**The City of Lake Forest
Zoning Board of Appeals' Meeting Agenda**

Monday, November 23, 2020

1150 E. Westleigh Road Pool Setback Variance

2 N. June Terrace Front and Side Yard Setback Variances

Sheet Title:
Pool Area
Concept
& Existing Trees

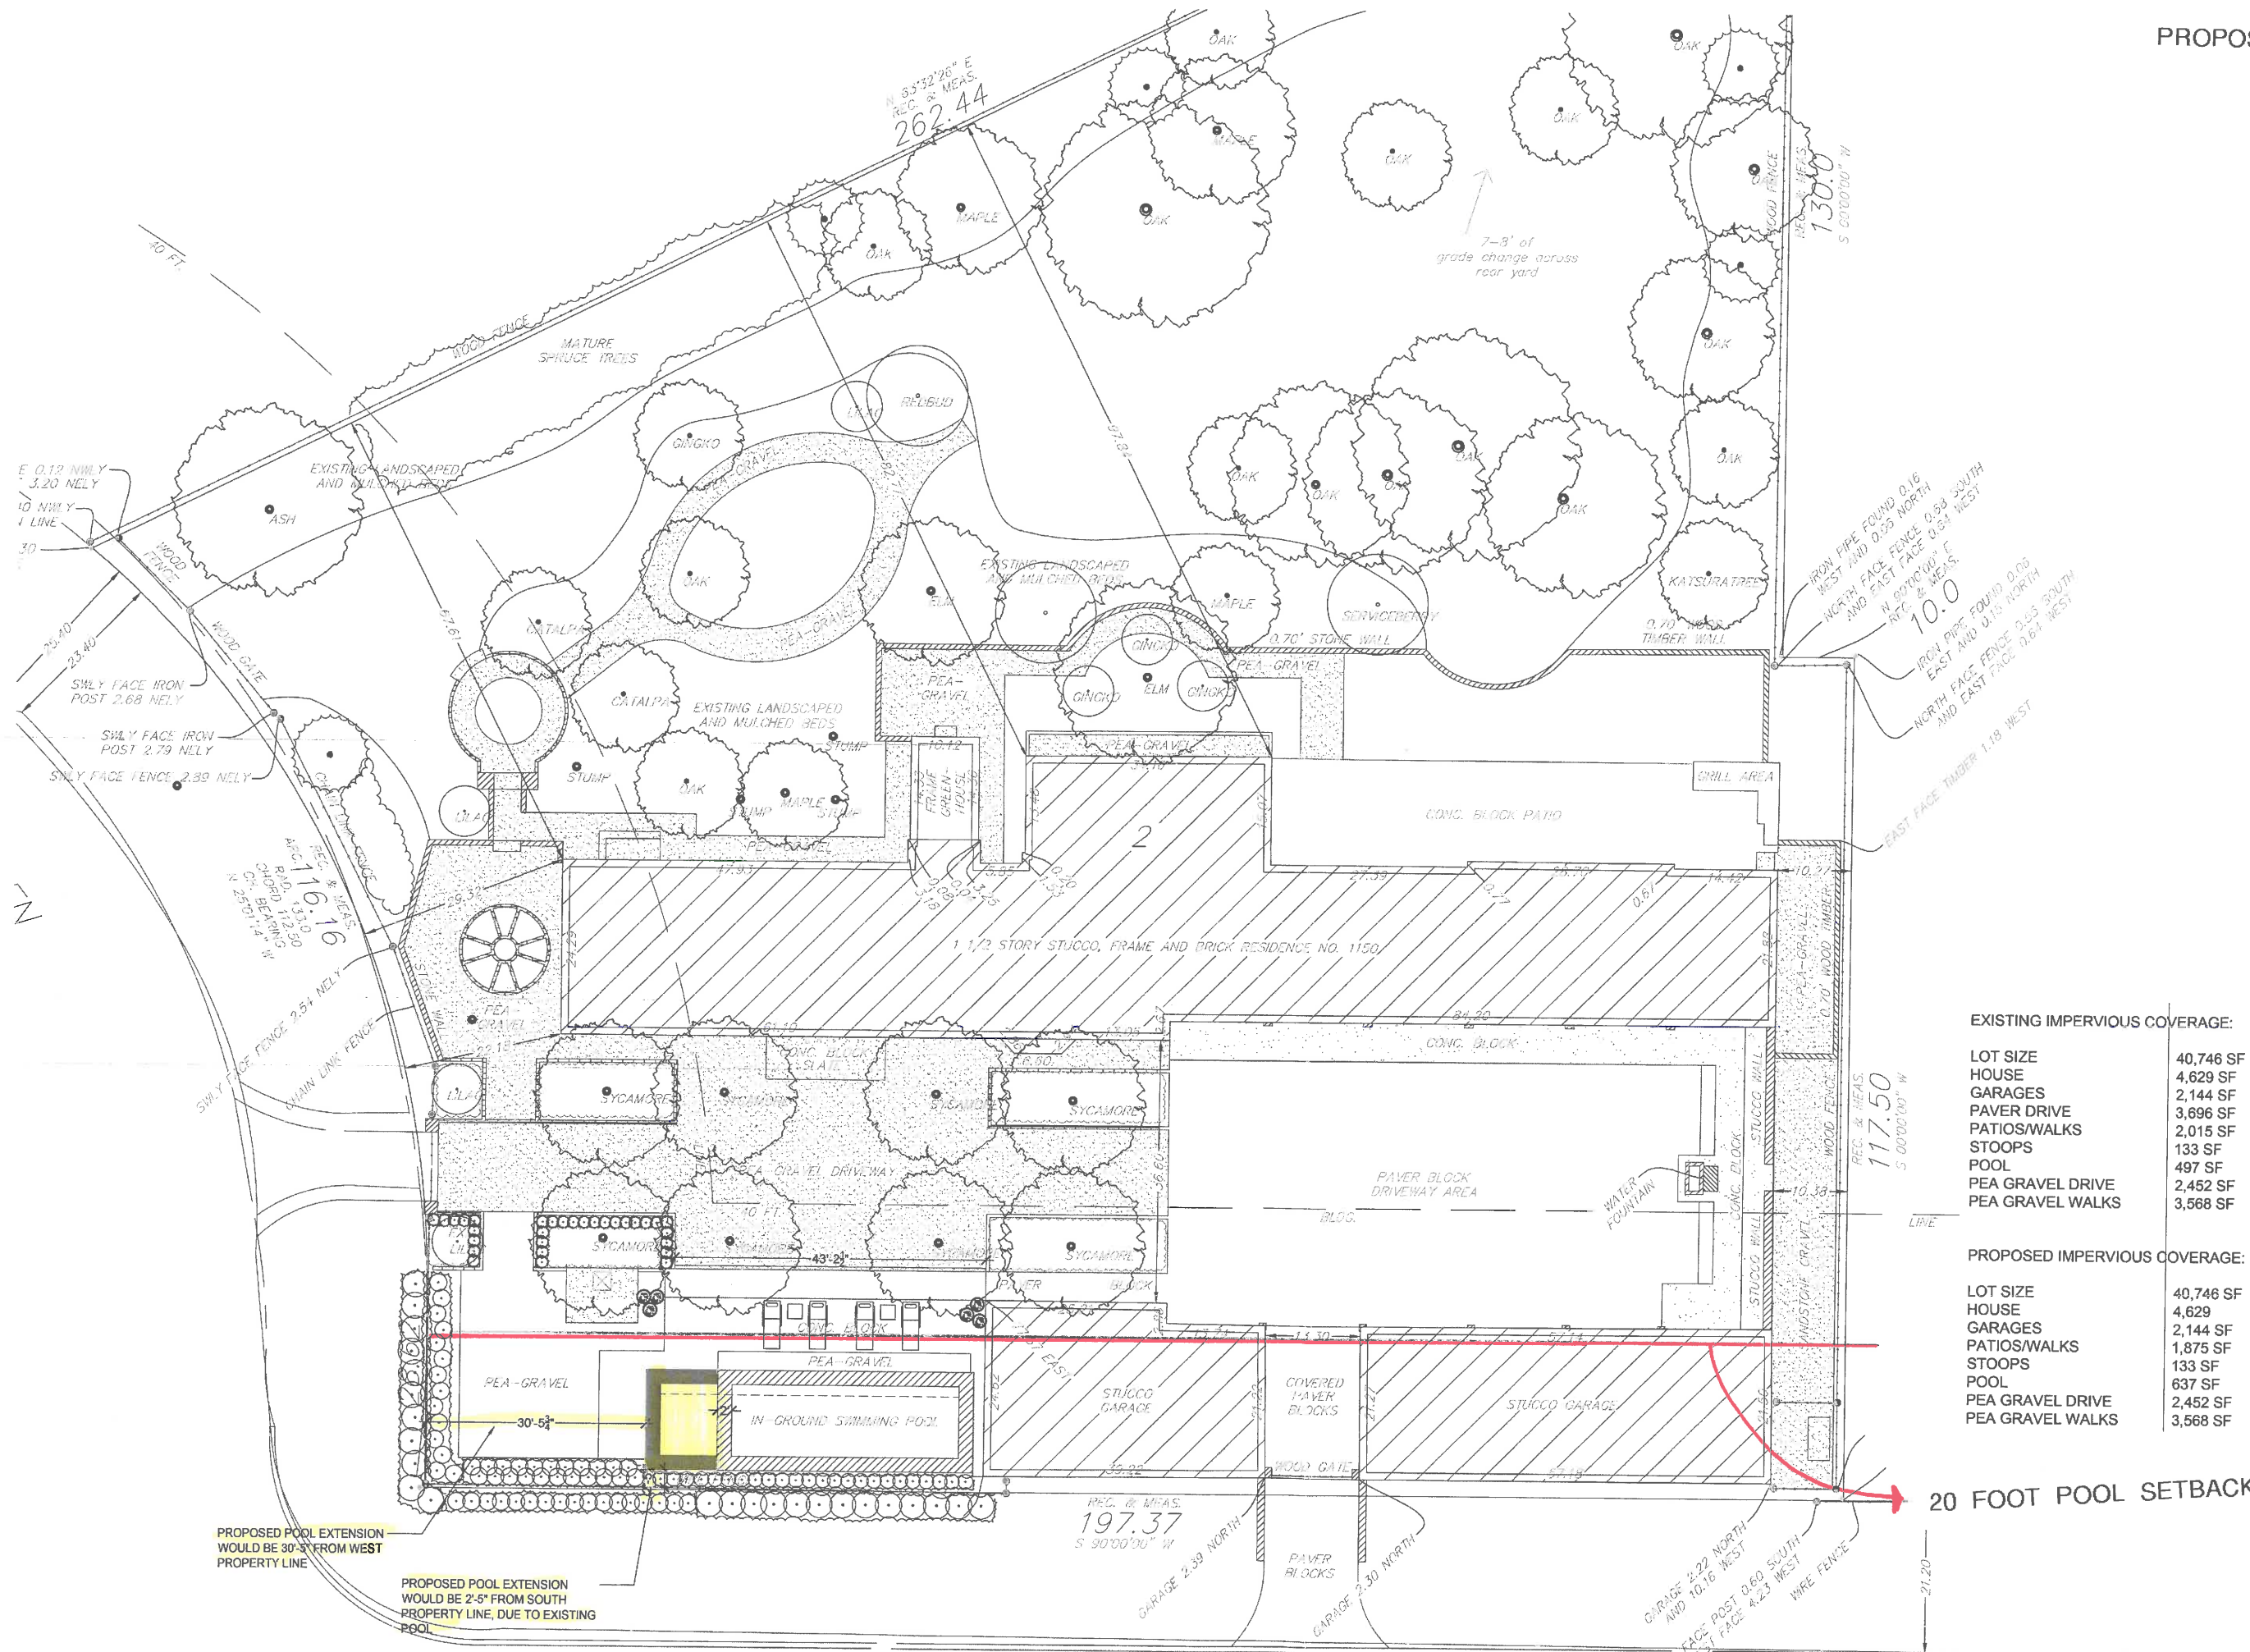
This is a request for approval of a variance from the required 20 foot pool setback to allow the existing non-conforming pool to be elongated by 10 feet. The existing pool is an adaptive reuse of a trough associated with the stables of the McCormick Estate, Walden.

- ❖ The existing pool, the original trough, does not comply with the current setback requirements for pools.
- ❖ The proposed extension of the pool, to allow lap swimming, proposes to extend the pool 10 feet to the west, within the 20 foot pool setback from the south property line.

The proposed extension in the length of the pool will be consistent with the width of the existing pool, ten feet wide, and will encroach into the required 20 foot setback along the south property line to the same extent as the existing pool. The existing pool, is located 2.5 feet from the south property line. The petitioners desire to lengthen the pool to accommodate swimming laps.

Based on the findings presented above, recommend approval to the City Council of a variance to allow a ten foot extension of the pool, no portion of which will be located closer than 2.5 feet to the south property line consistent with the site plan submitted to the Board.

NORTH AND EAST ELEVATIONS - EXISTING AND PROPOSED

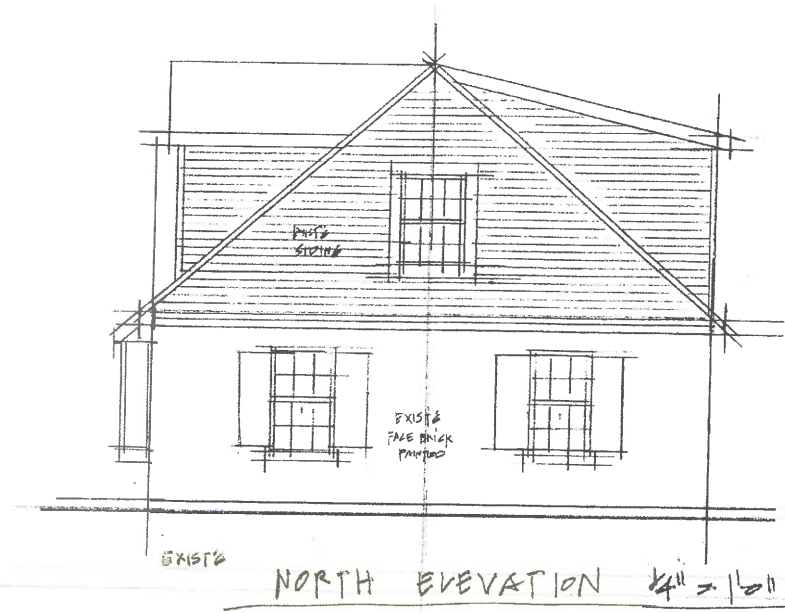
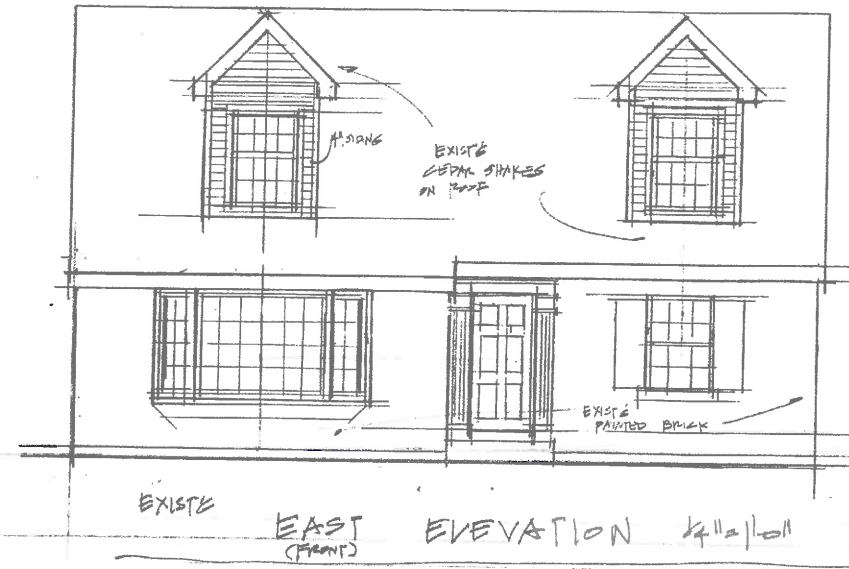
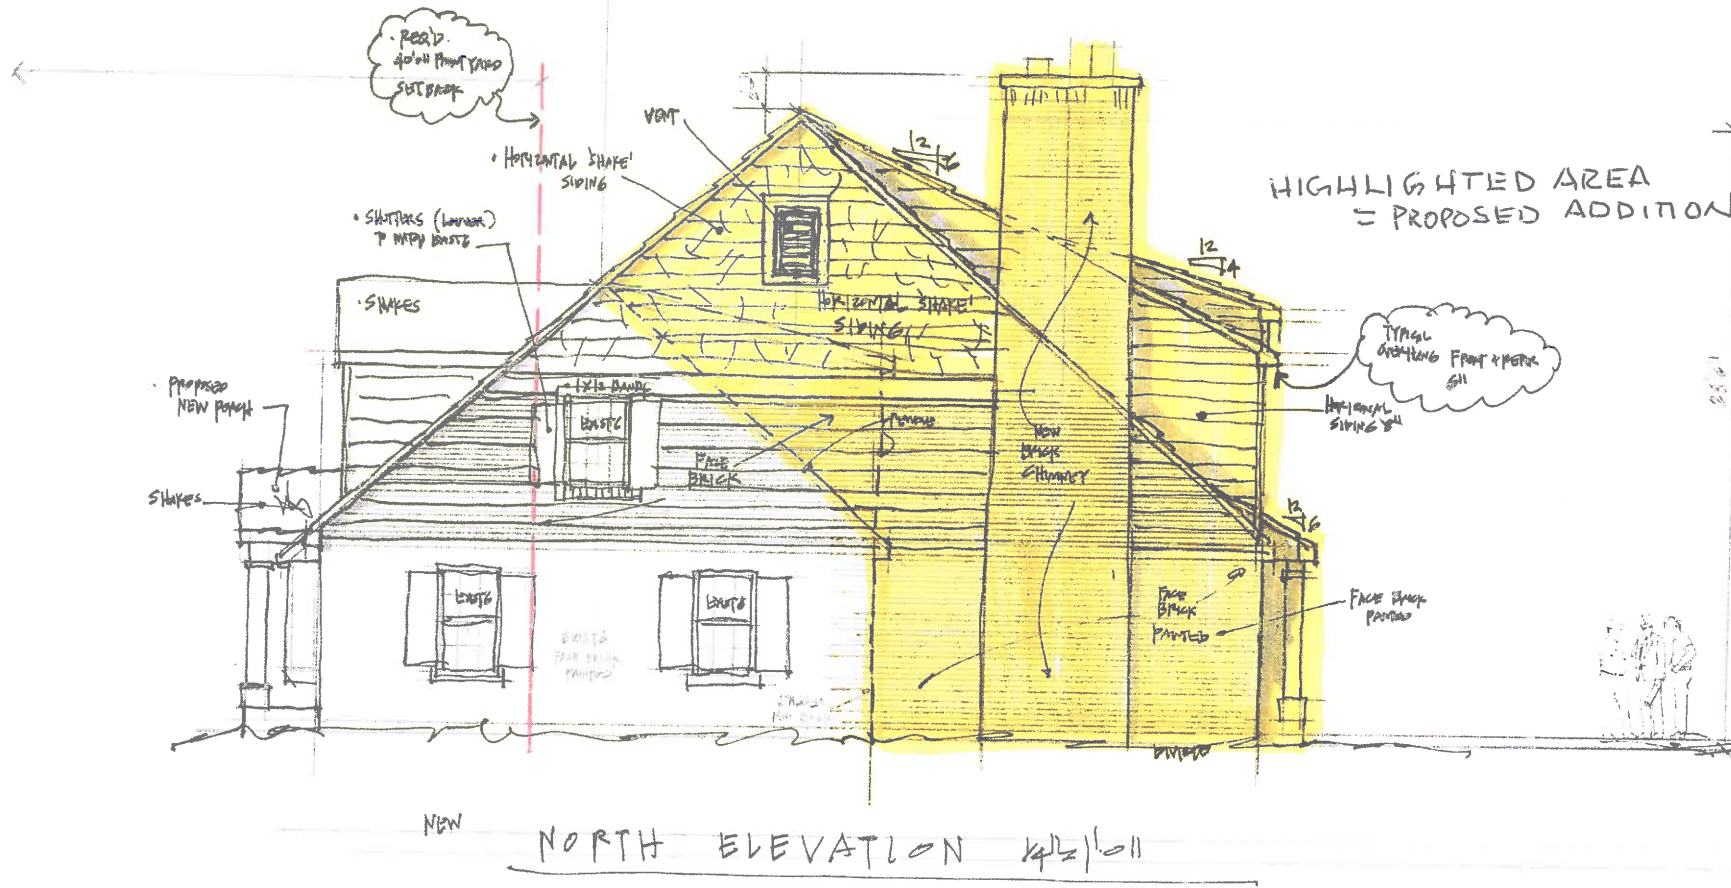
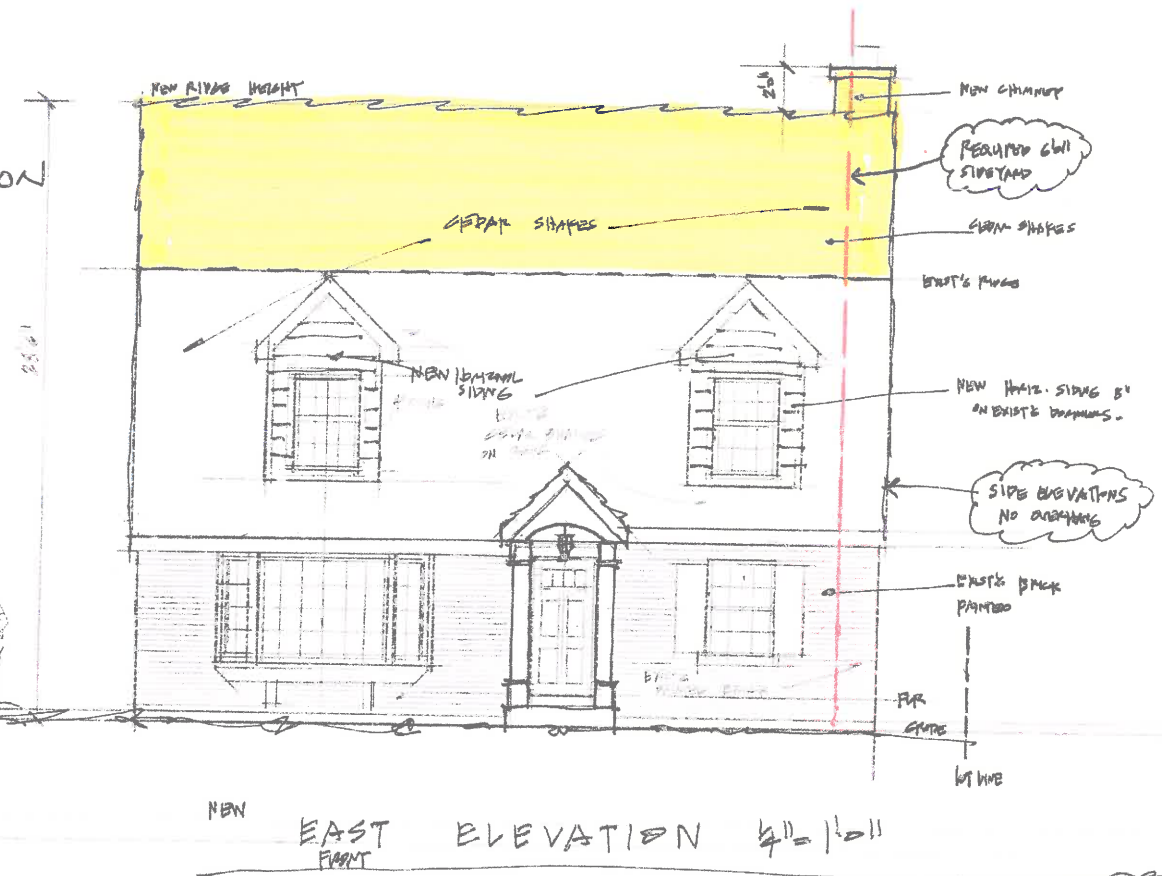
Substantial demolition of the existing home is proposed to accommodate significant expansion of both first floor and second floor living space. Based on plans submitted, the raised roof, the extended north wall and the chimney all encroach into the side yard setback. Although the encroachment of the new building mass encroaches into the side yard setback on the north side to the same extent as the existing house, 4' 4" from the property line, the building mass located within the setback is more than doubled as a result of the proposed increased height and length. The new ridge of the roof is proposed at eight feet above the existing roof ridge increasing from 20'6" to 28'6". A portion of the raised roof is within the side yard setback as noted below.

- The additional mass proposed to be constructed in the side yard setback on the north side of the house for the proposed addition will change the relationship of this house to the neighboring property. Although a modest encroachment exists today with the one story house, the proposed construction would more than double the mass of the building in the setback and increase the height within the setback area by an additional eight feet.

Based on review of the information submitted by the petitioners, site visits and an analysis of this portion of the request based on applicable portions of the Zoning Code, staff recommends further study and exploration of ways to expand the house without constructing significant additional building mass within the required setback.

PROPOSED LANDSCAPE PLAN

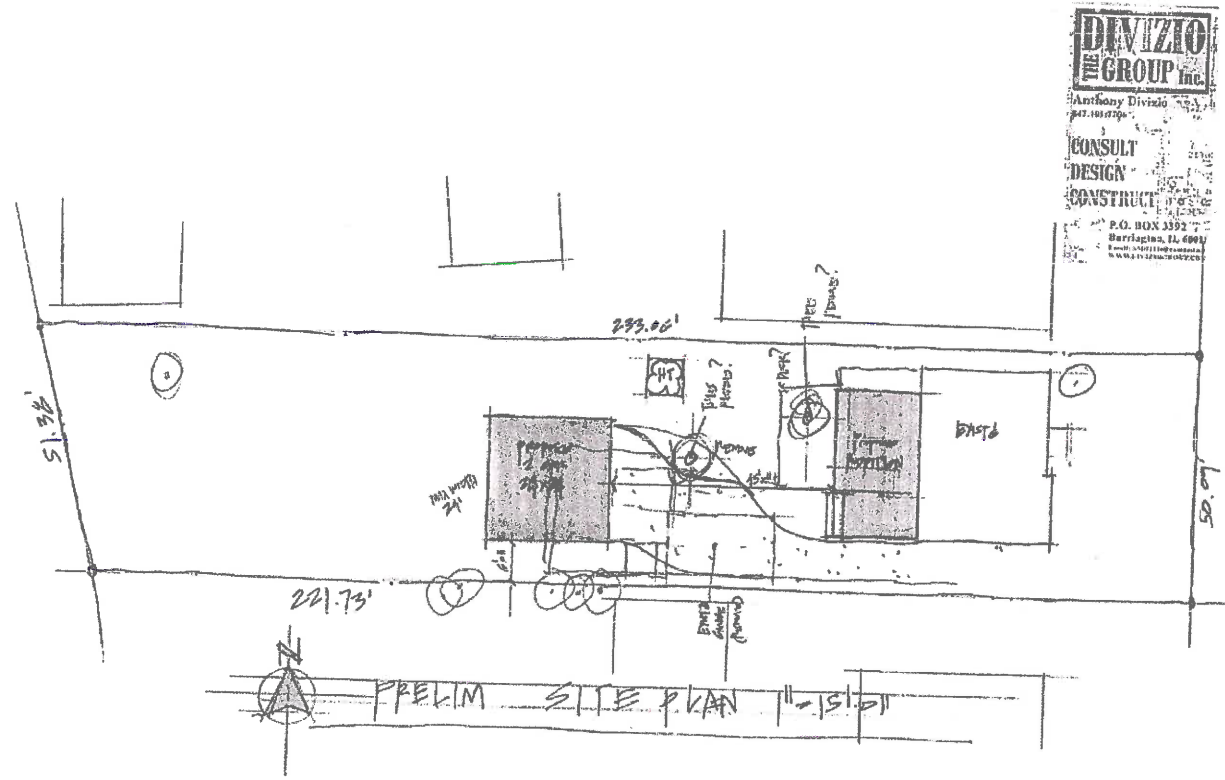
No landscaping is proposed as part of this project, along the north property line because there is not adequate space or light to support landscaping screening between the two homes. There is an existing fence that runs from approximately the rear of the existing house along the north property line, to the rear lot line.
